Traffic Engineering Response to Council Information Request

To	Courtney Upper Coomera Developments Pty Ltd	Date	28 August 2026
Prepared by	Kevin Liu, Modus Traffic Engineer	Approved by	Harj Singh, Modus Executive Director (RPEQ 22364)
Location	17 Courtney Drive, Upper Coomera		
Subject	Proposed Residential Subdivision Development - Traffic Engineering Response		
Status	Final	Attachments	Appendix A: Council Information Request Appendix B: Revised Development Plans Appendix C: Swept Path Assessment

Information Request Item 8

STAGING PLAN - STAGE 2

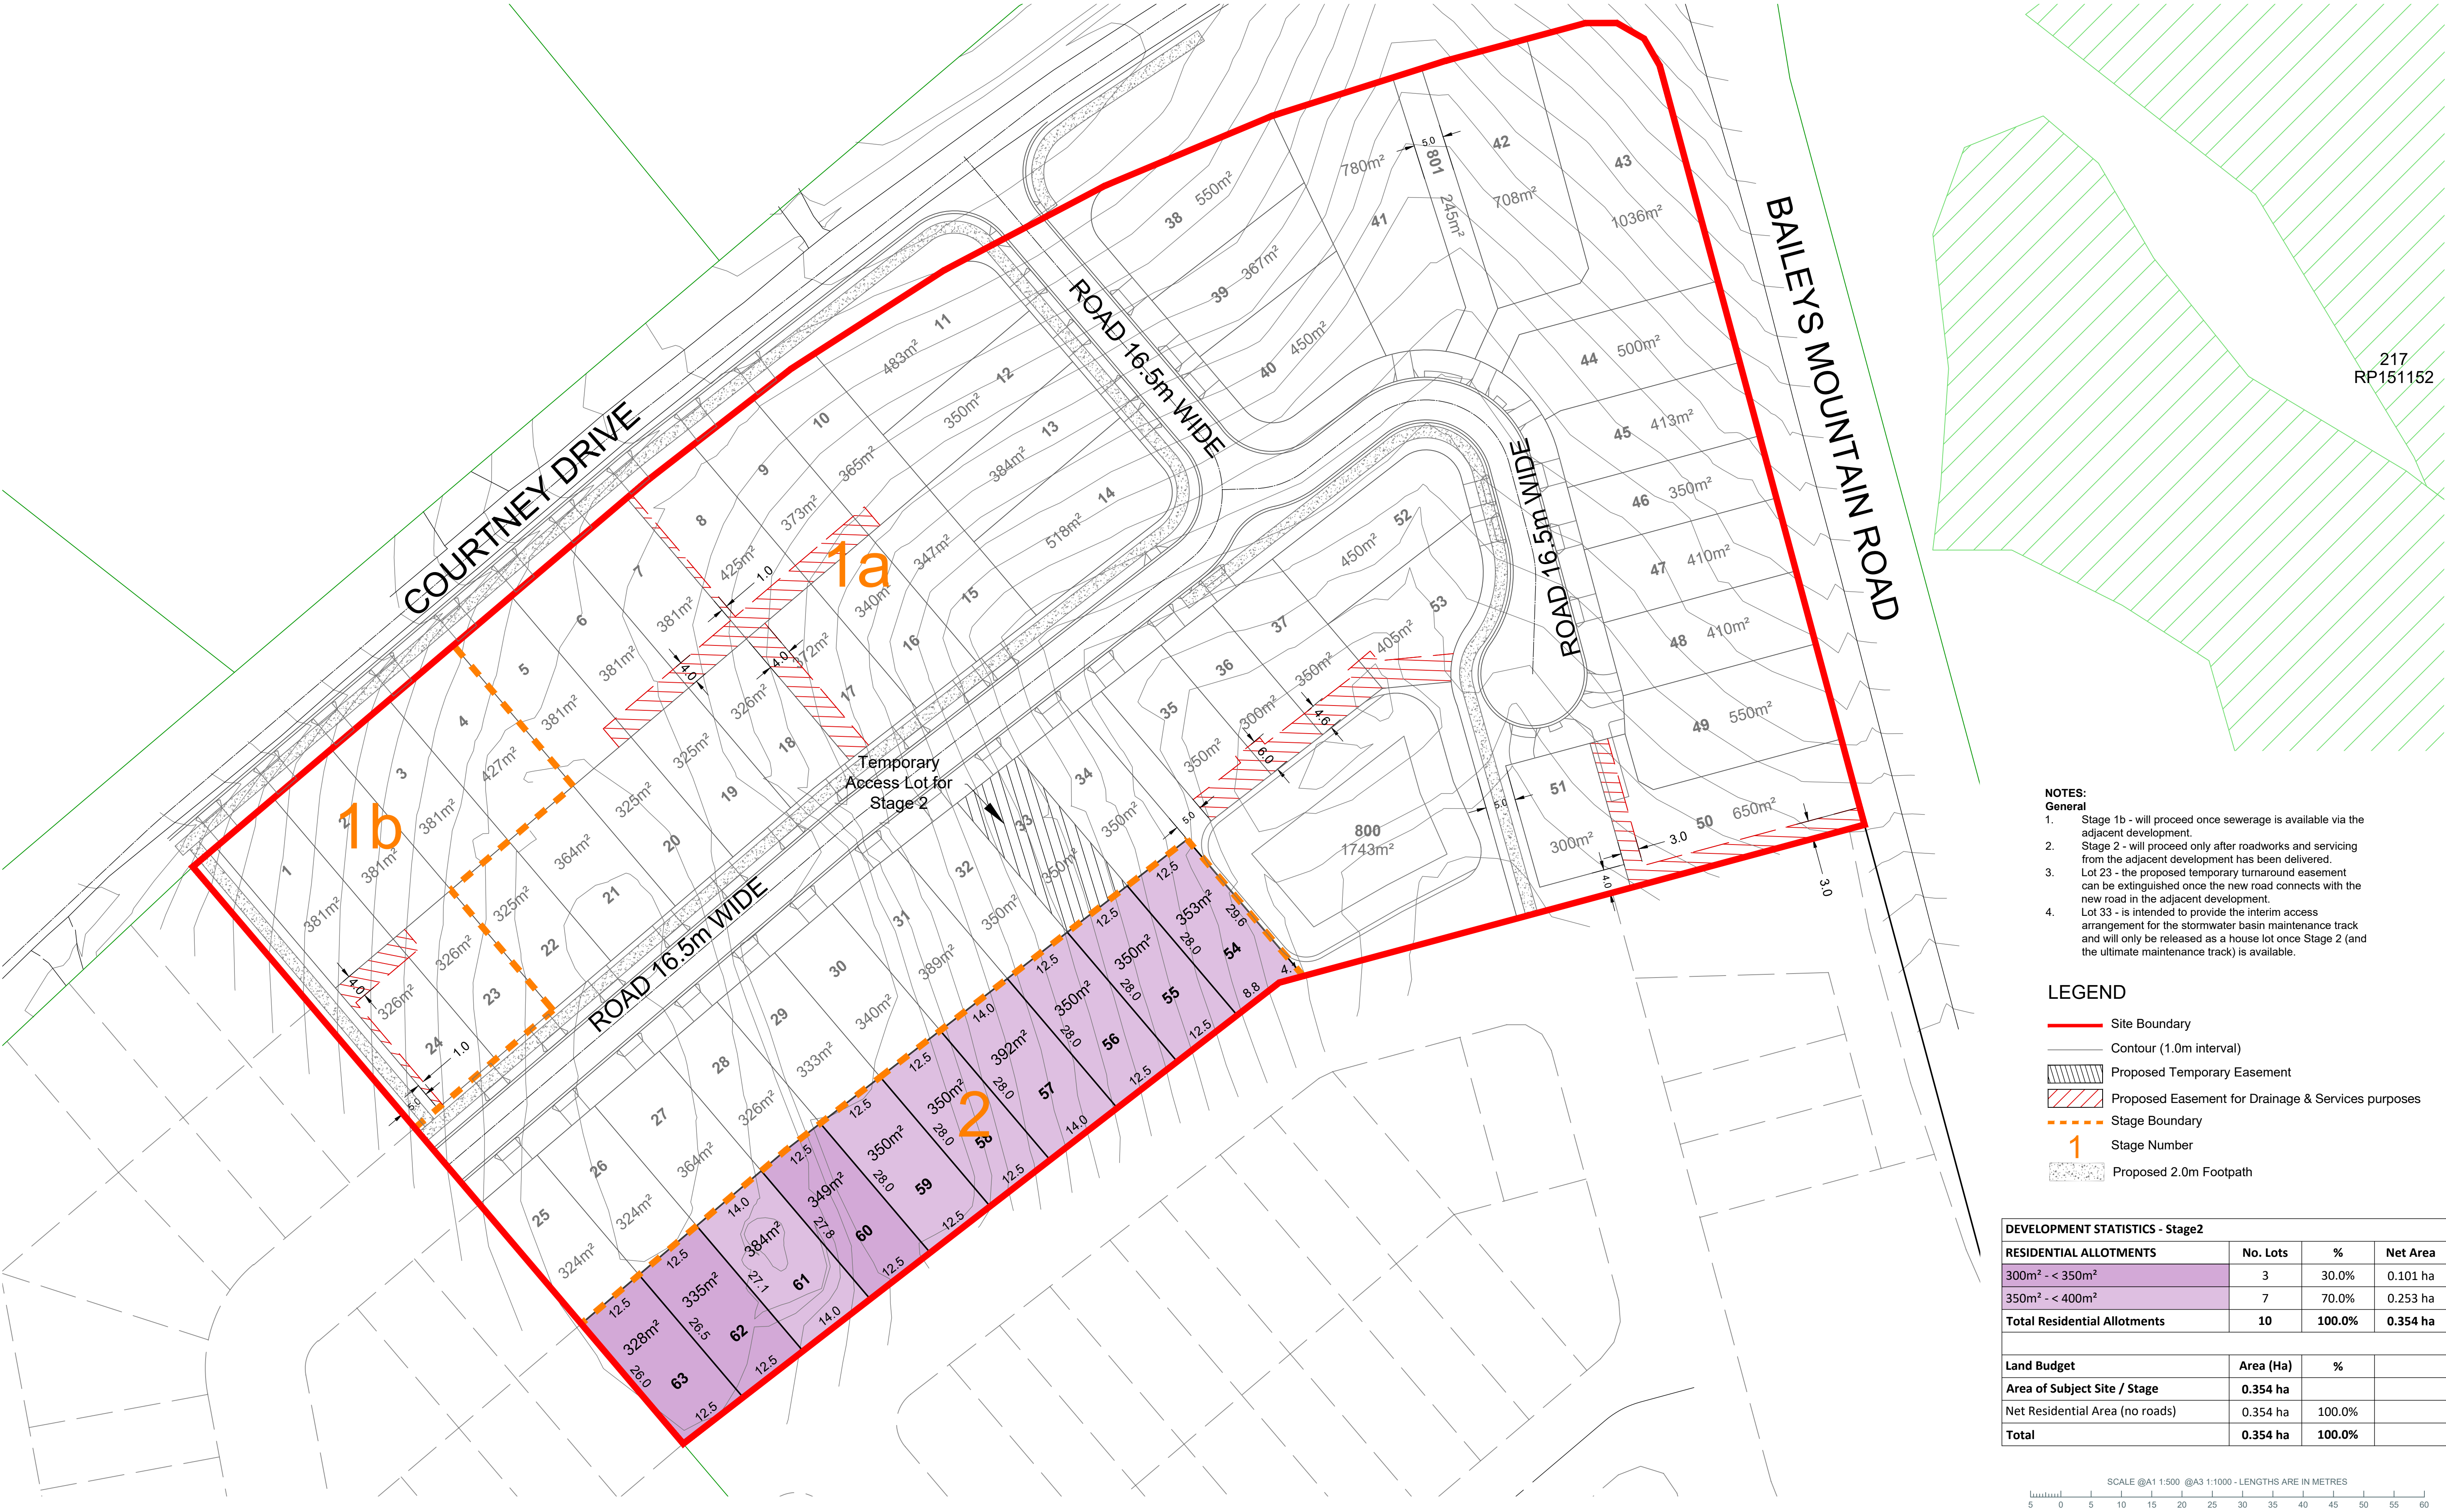
- d) Provide an updated ROL plan, demonstrating the size and location of bin pads for proposed lots with narrow or constrained frontages (i.e. Lots 41, 42, 43, & 44, or where the Road 01 temporary dead-end exists) to ensure a side-loading refuse collection vehicle can adequately service each proposed lot within the development site.*

The revised ROL plan identifies nominated bin presentation areas for Lots 41, 42, 43 and 44, together with the relevant constrained frontage areas associated with the temporary Road 01 arrangement.

The nominated presentation areas have been positioned adjoining the public road frontage so that bins can be presented for collection from the subject lot frontage while maintaining access for the side-loading RCV.

DRAWING NUMBER
MOD25094QLD - SK02

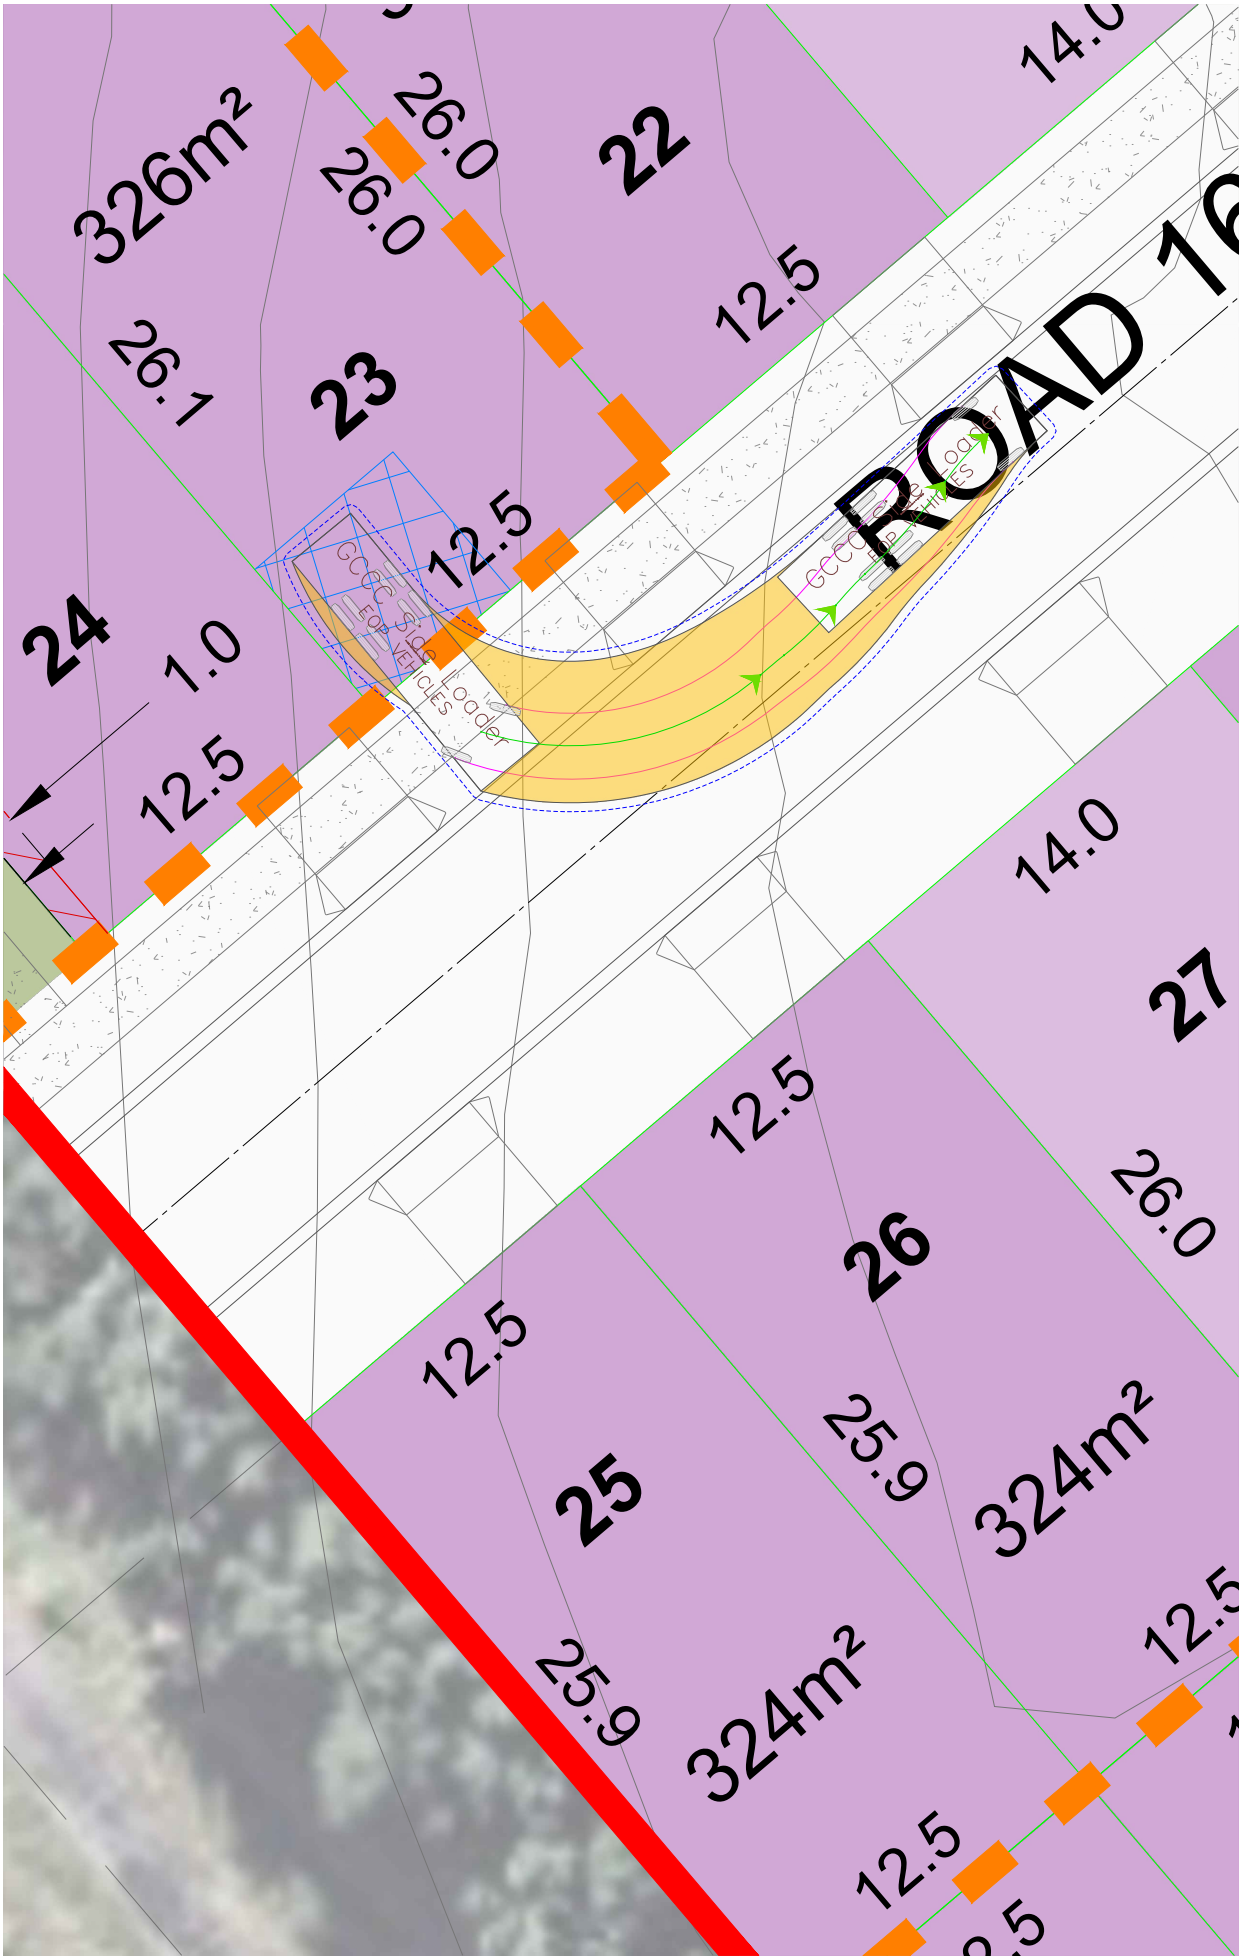
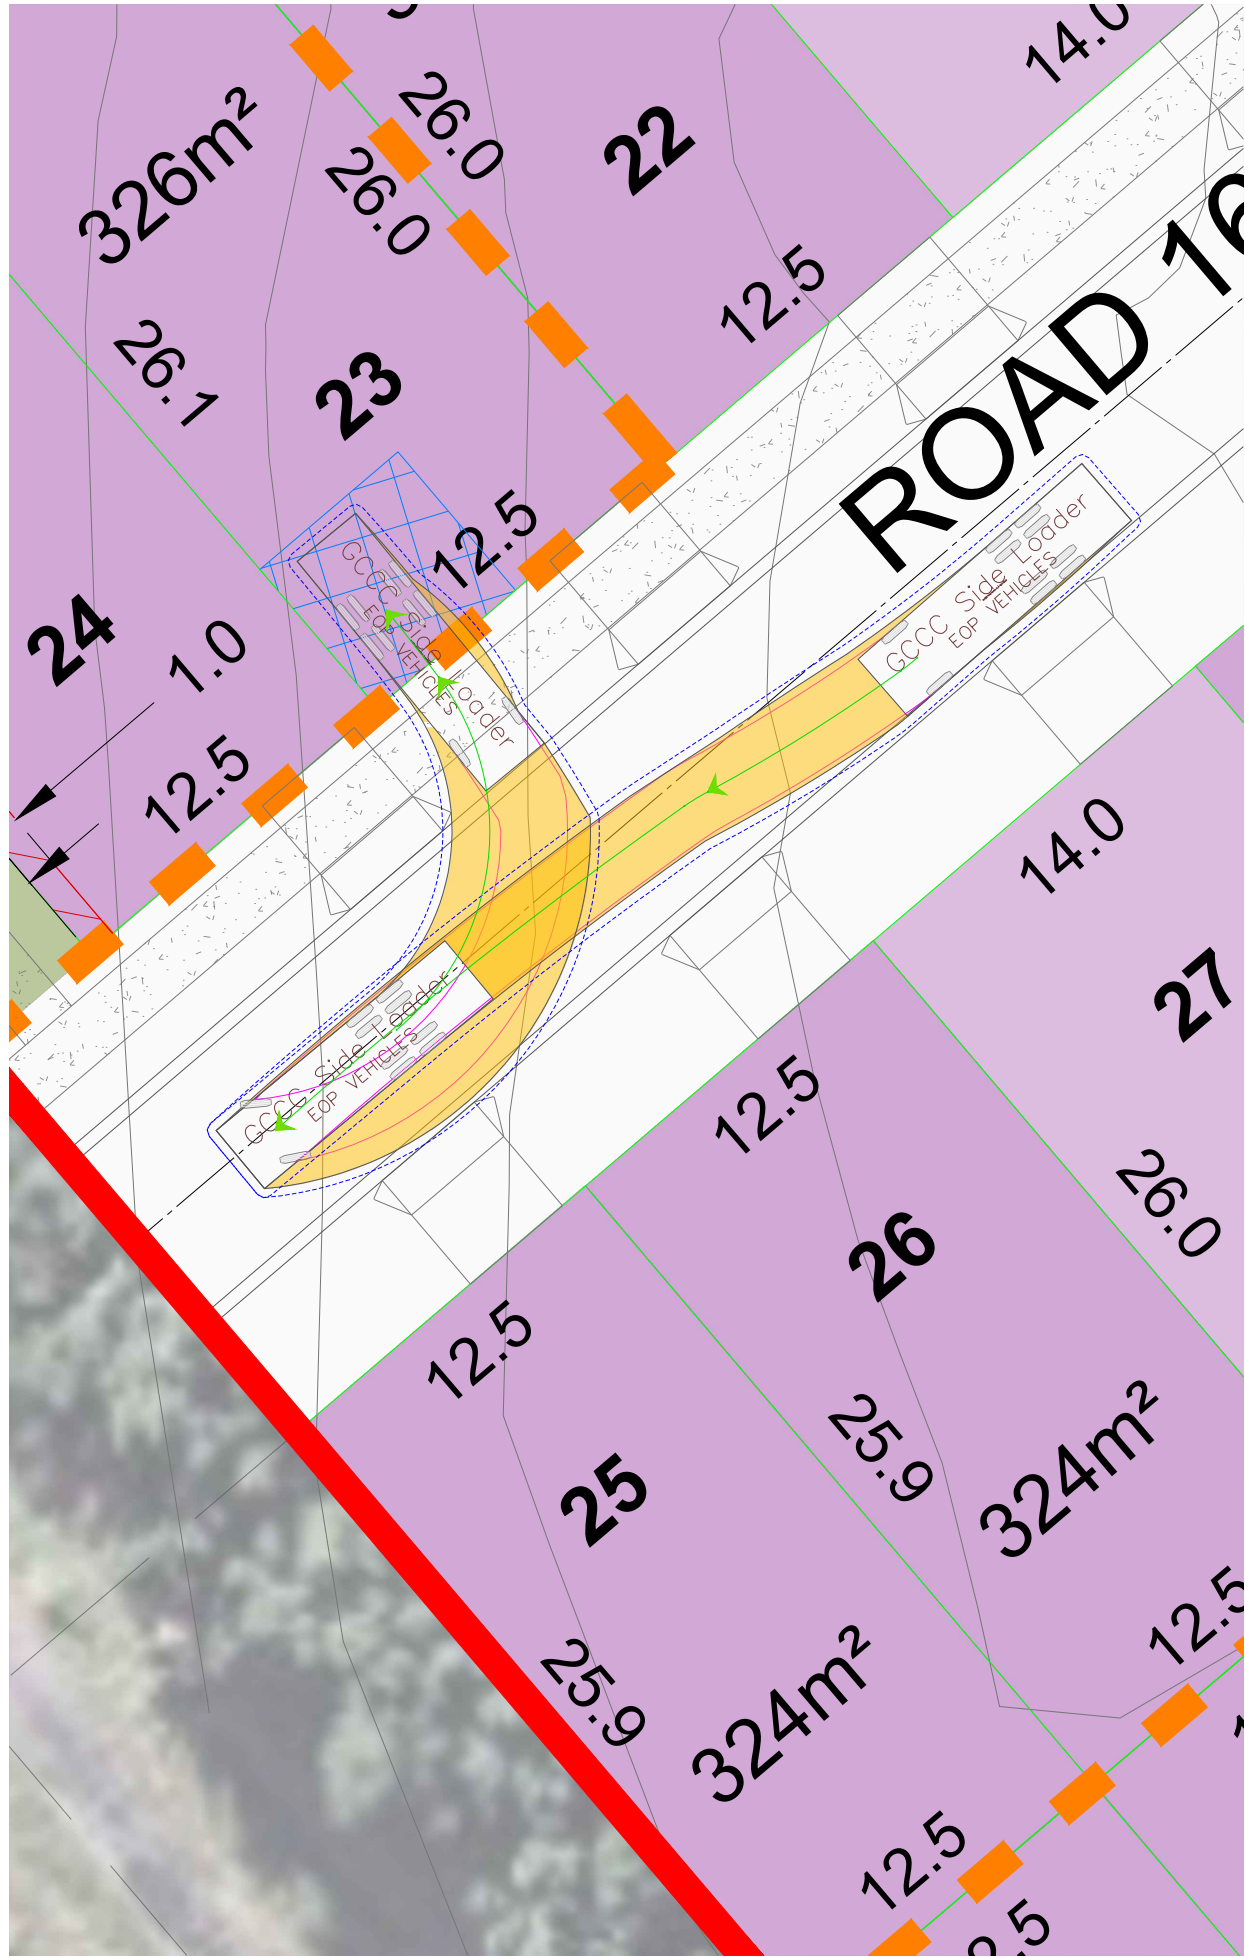
Council acknowledges the RCV swept path diagram, prepared by Modus Transport and Traffic Engineering as part of the application submission material, it however remains unclear to Council how the proposed Road 01 dead-end will facilitate safe and efficient access for the CoGC RCV prior to the neighbouring development extending the road network through their site. The applicant is therefore requested to demonstrate an interim refuse collection arrangement for the Road 01 dead-end, which may consist of either:

- a) A minimum 18m diameter, temporary cul-de-sac head at the Road 01 dead-end. This would facilitate RCV turning, though would likely impact the footprint of Lots 24, 25, and 26; OR,*
- b) A dedicated temporary turnaround lot, which would remain as the nominated RCV turnaround until such time that the adjoining development continues Road 01 through their development. Specific conditions of approval would be imposed to restrict the plan sealing of the nominated RCV turnaround lot.*

- c) Amend the RCV Swept Path diagram to include:*
 - i. Demonstration that the proposed temporary RCV turnaround arrangement is achievable (i.e. a CoGC side-loading RCV can safely and efficiently navigate the turnaround); and,*
 - ii. Include vehicle specification in accordance with SC6.16 City Plan Policy – Solid Waste Management, including the kerb-to-kerb turning radius as nominated in Appendix C; and,*
 - iii. Ensure the RCV Swept Path is signed by an appropriately qualified RPEQ.*

Council's Option (b) has been adopted. A dedicated temporary RCV turnaround arrangement is proposed at the Road 01 termination, incorporating part of Lot 23, in lieu of an 18m diameter temporary cul-de-sac.

A dedicated temporary RCV turnaround arrangement has been incorporated at the temporary termination of Road 01, with part of Lot 23 nominated for this purpose.

The turnaround area is to remain available and unobstructed for refuse collection vehicle manoeuvring for the duration that Road 01 operates as a temporary dead-end. Lot 23 is therefore to remain subject to the temporary turnaround arrangement until Road 01 is extended through the adjoining development and the temporary turnaround is no longer required for refuse collection access.

Swept path assessment drawing **MOD25094QLD-SK02 Rev C** demonstrates the nominated City of Gold Coast side-loading RCV entering the temporary turnaround area, undertaking the required manoeuvre and departing Road 01 in a forward direction.

The RCV swept path assessment has been revised in response to Council's request.

The assessment adopts the nominated City of Gold Coast side-loading refuse collection vehicle and identifies the relevant vehicle specifications, including a 9.83 m vehicle length and 10.50 m kerb-to-kerb turning radius, consistent with the vehicle nominated for the assessment.

Drawing **MOD25094QLD-SK02 Rev C** demonstrates the RCV manoeuvring within the proposed temporary Road 01 turnaround arrangement. The simulation has been undertaken at a design speed of 5 km/h and incorporates a 300 mm vehicle clearance envelope..

On the basis of the swept path assessments, the nominated CoGC side-loading RCV is able to undertake the modelled refuse collection movements within the available road and temporary turnaround geometry.
